## The hill track at Cairngorm â?? a test case for the National Park (2)

The Officers Report for the Cairngorms National Park Planning Authority meeting on Friday which will consider the hill track at Cairngorm is as interesting for what it leaves out as for what it includes. This is over and above the policy omissions and enforcement failures considered in yesterdayâ??s post.

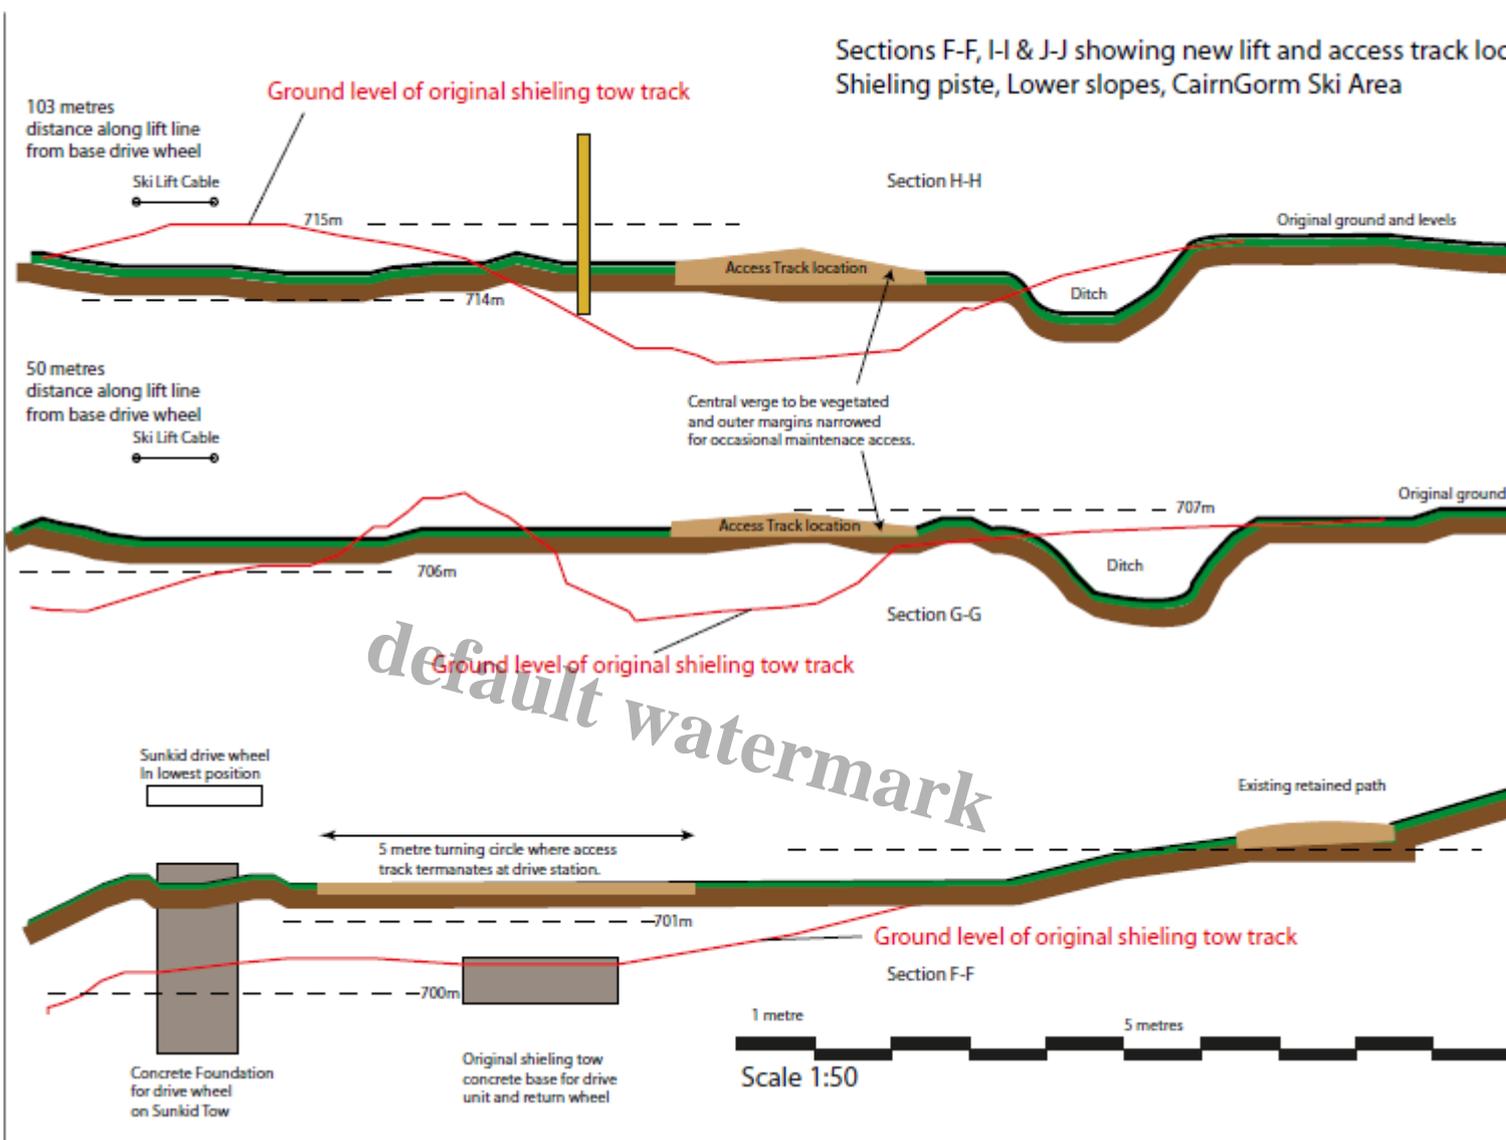
There has been a lot of nonsense talked about the hill track being needed for construction purposes. This diagram from Appendix A to the Committee Report shows that this couldn't have been the case. The elevation of the new track is HIGHER than the previous shieling tow uptrack which sat between two bulldozed banks (section GG). In other words the hill track could only have been created AFTER the slope had been smoothed out (which was agreed in the original planning application). This explains why there is NO evidence of any temporary construction track. There wasn't any. Natural Retreats appears to have confused the original ski uptrack with the new hilltrack in order to make the latter appear more acceptable by implying this had already been agreed on a temporary basis.
